**APPLICATION
 FOR PERCOLATION TESTING AND SITE EVALUATION**

Percolation Test Report; 7157 Deer Valley Road, Highland, MD 20777

PERCOLATION APPLICATION PLAN
JARED PROPERTY
 7157 DEER VALLEY ROAD

PERCOLATION CERTIFICATION PLAN
CINER PROPERTY
 7157 DEER VALLEY ROAD

7157 Deer Valley Rd (mn)

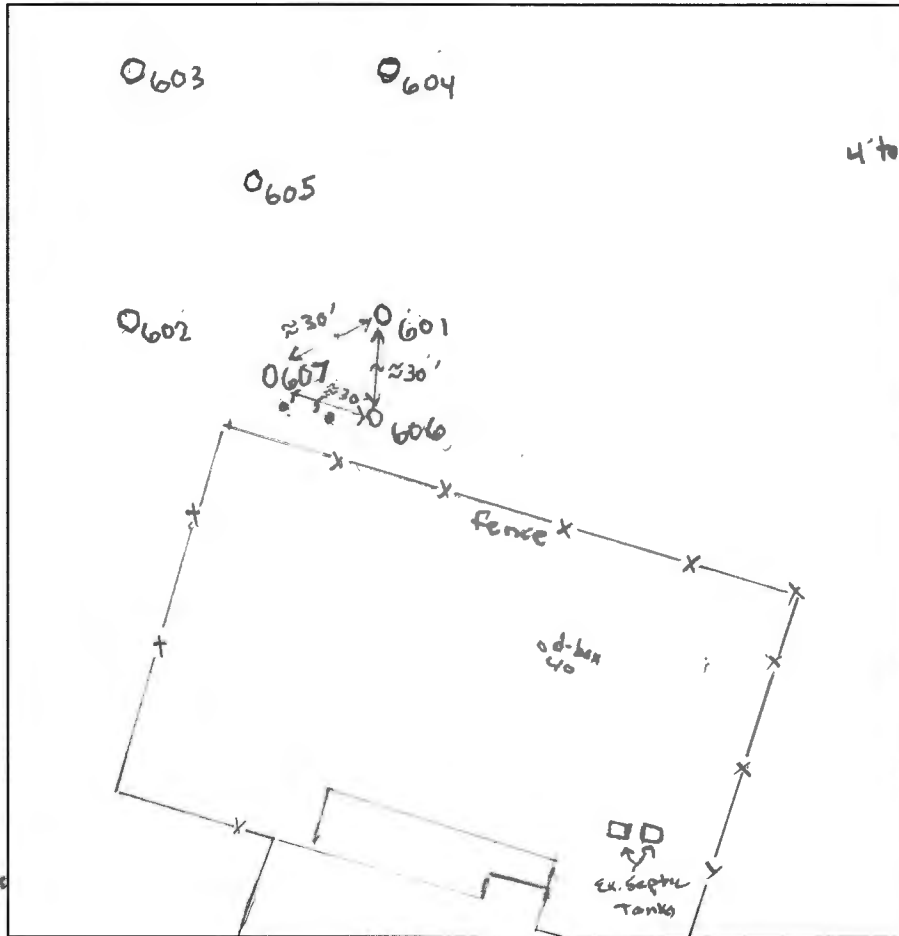
Percolation tests were conducted at 7157 Deer Valley Road, Highland, MD 20777 (Tax Map 40, Parcel 377) on May 31, 2022. Tests and profile descriptions were documented for 7 locations. 5 test holes passed while test hole 601 (did not test - see profile) and 606 (33-minute rate) failed. Test hole 601 had a very "tight" soil profile with sandy clay loam to 6 feet and platy/rock to 8 feet.

Two of three trench ends were field located just outside the fence and staked with a flag while onsite. Septic contractors were going to locate 3rd trench and stake the location. The d-box lines-up with the as-built drawing in record, and it's marked by a cleanout near a large tree.
